## AGENDA ITEM 9.3

### CATALOGUE SUB-COMMITTEE REPORT

#### Catalogue Change Proposals for 2011

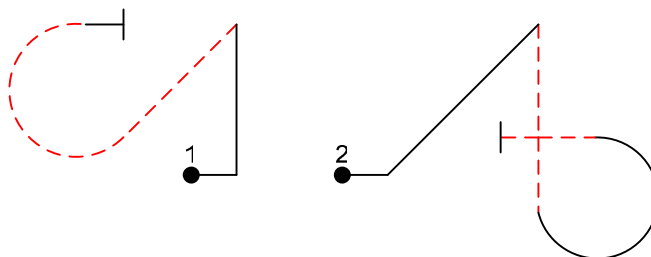
The shapes proposed were of these forms:

combining a wedge shape from Family 1 with a 5/8 or 3/4 loop. It was further proposed that these figures be included in Family 8.

I sought comments from other members of the Catalogue Sub-Committee, and these were unanimous in suggesting that these complex figures would not add anything of significant benefit to Family 8. Views expressed included that of Family 8 being already the largest Family with a great number of figures available for choice in Free and Known Programmes, but which were seldom, if ever, used.

The resulting recommendation of the Sub-Committee to plenary is **not** include these new basic shapes in Family 8 for 2011.
